## PRODUCT CHANGE NOTICE:

Material change for Inpac products

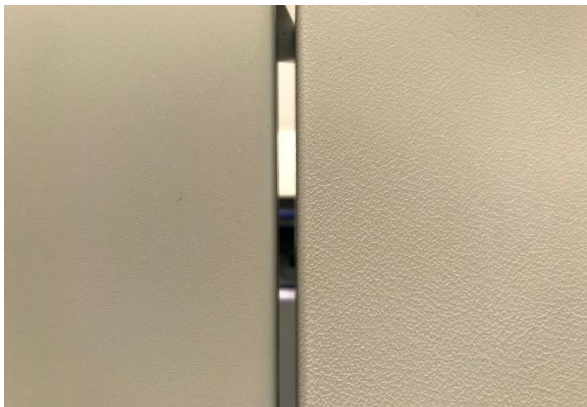
New material (left), current Material (right), The exterior surface will be the same color, RAL 7035, but with a finer texture.

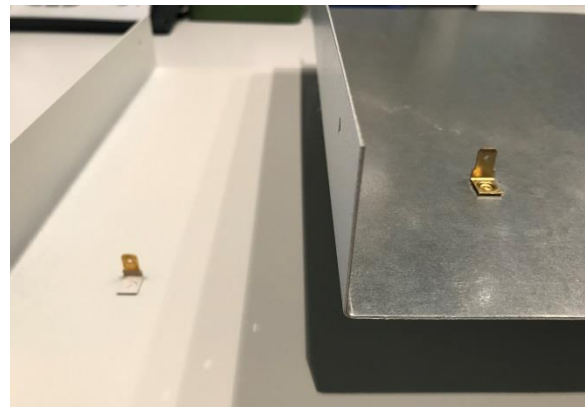
New material (left), current Material (right), All surfaces of the cover, including the interior, will be powder coated.
